ADDENDUM #1

Project Name: Currituck Community Park Signage

Owner: County of Currituck

Date: 08/13/2013

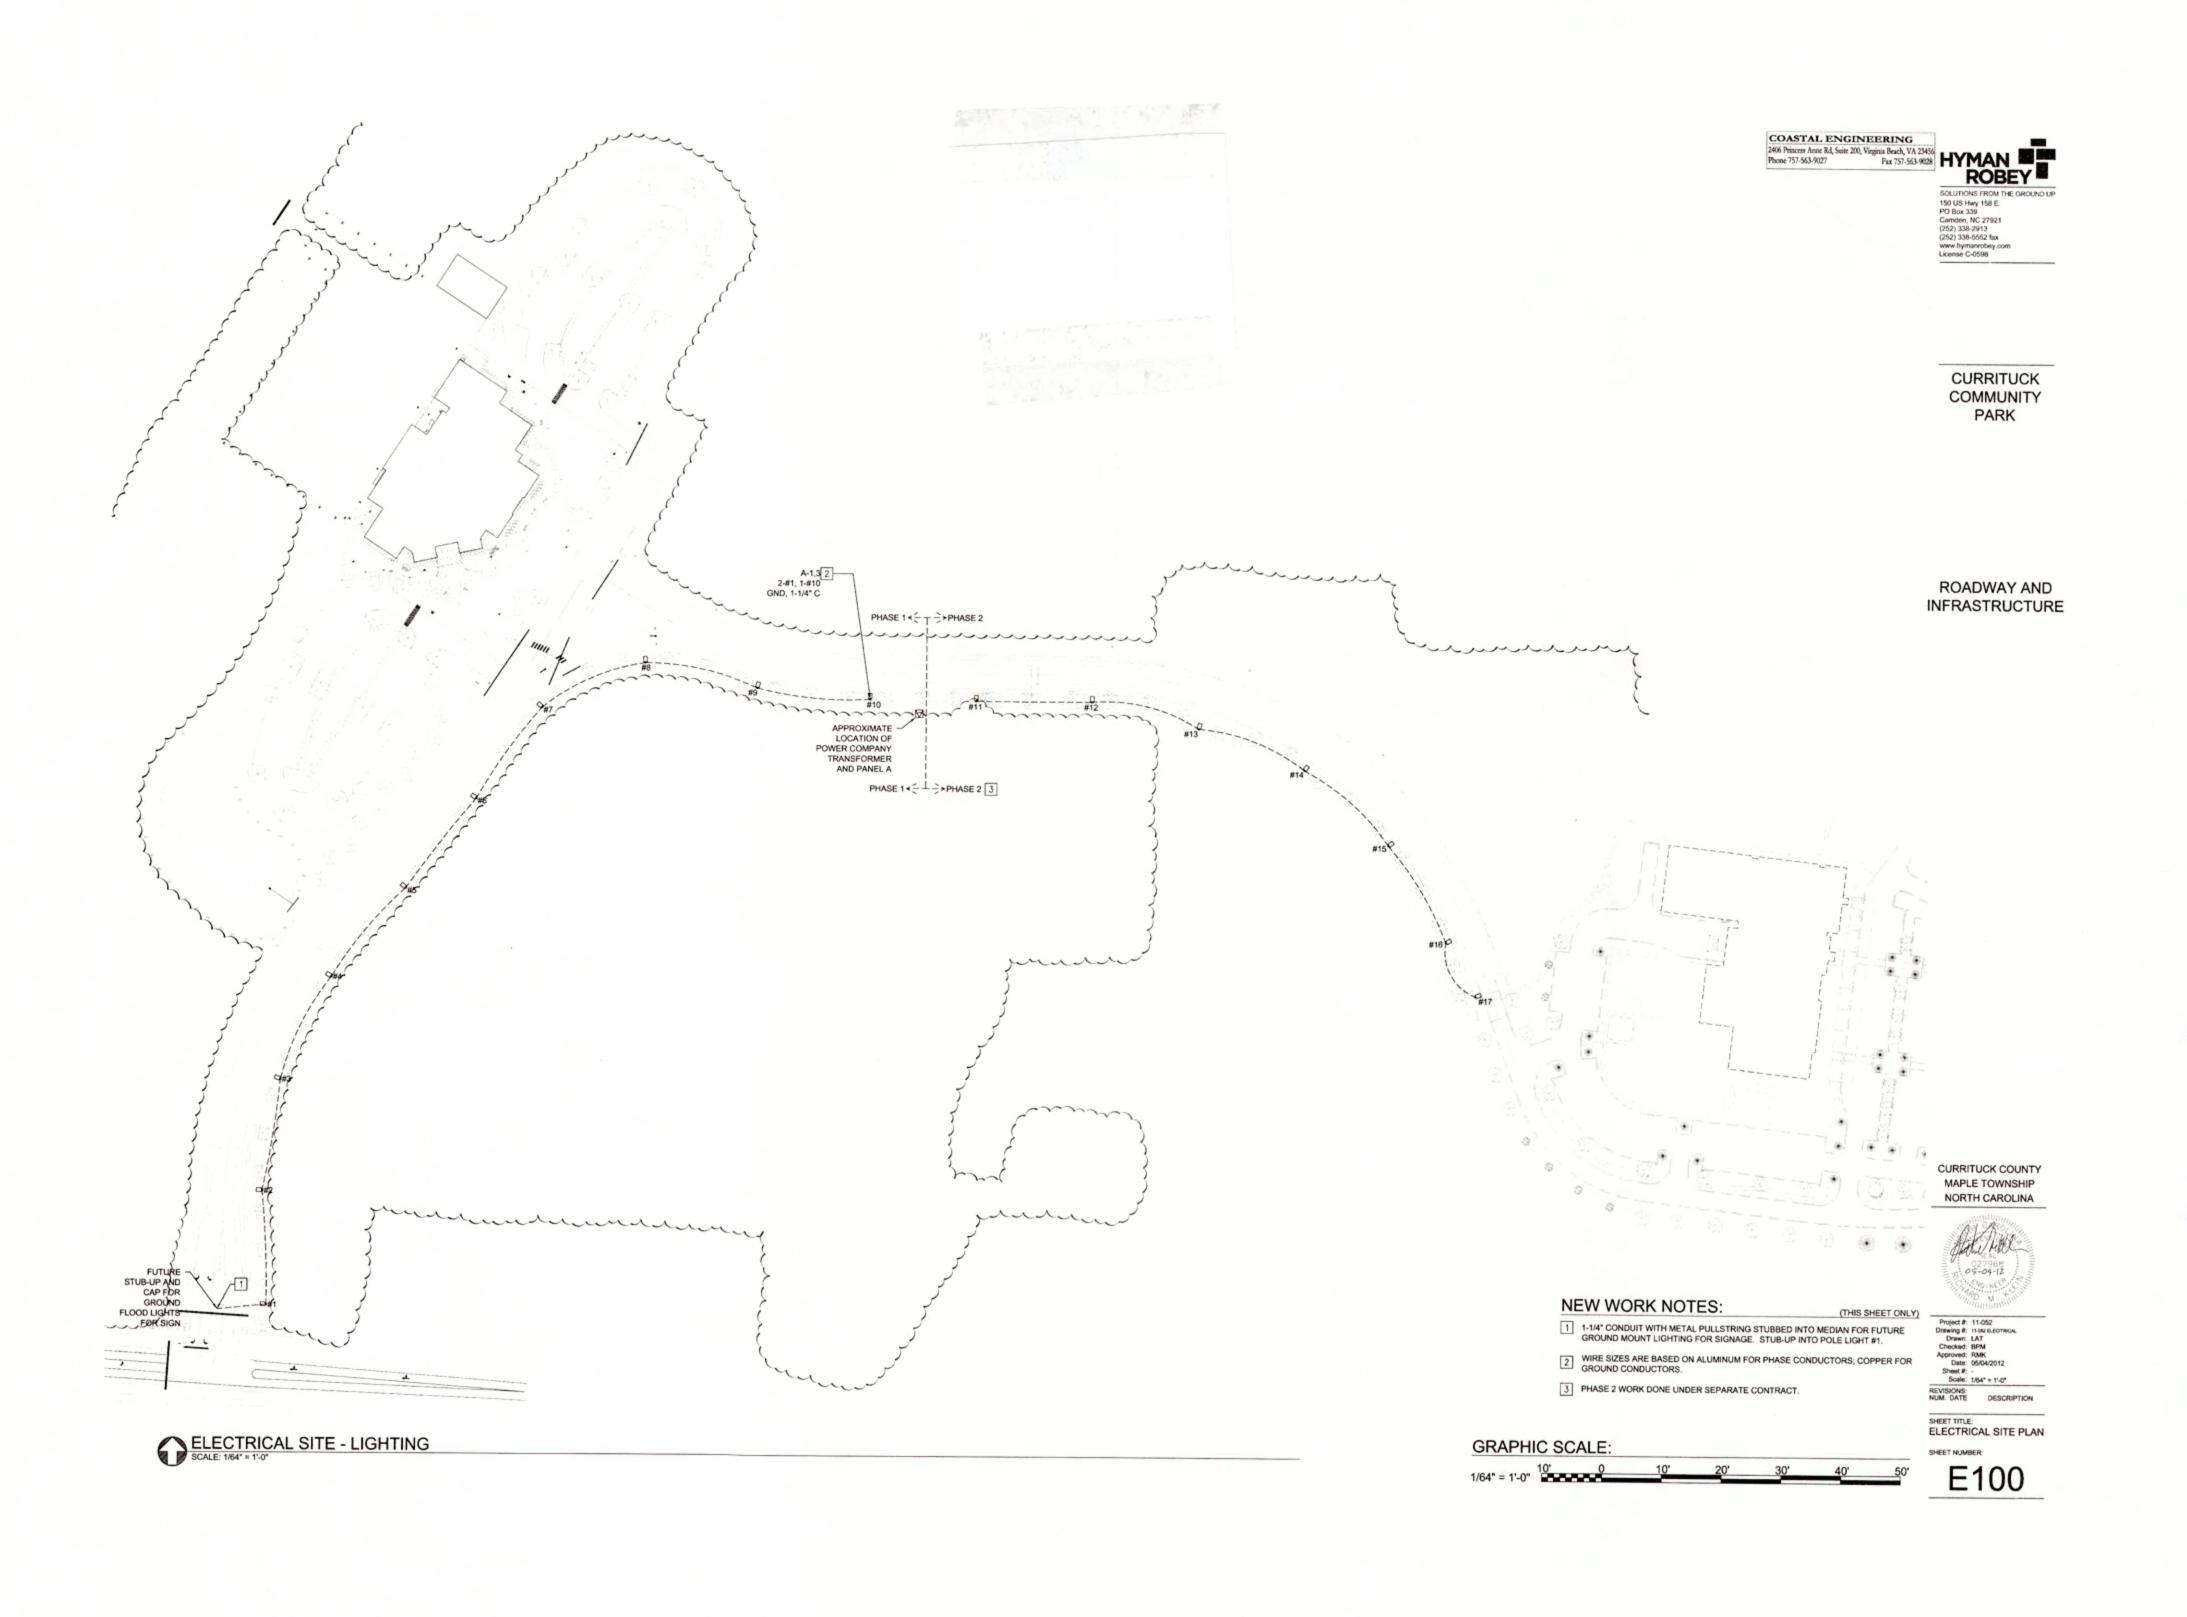
- 7. In the specs, it is mentioned that the landscaping is by Owner, but in the scope of work, landscaping is included. If landscaping is included, what all needs to be on the bid form?

- -Landscaping is included in the bid. The bid is lump sum.
- 8. For the Directional/Building identification signs, what is the depth of those signs?

-Use the same section view for the Building Signs as is shown for the Entrance signs.
- 9. For the Building/Facility identification signs, are the faces panels or cabinets?

-Use the same section view for the Building signs as is shown for the Entrance signs.
- 10. Are we responsible for all the masonry walls and bases as well?
 -Yes
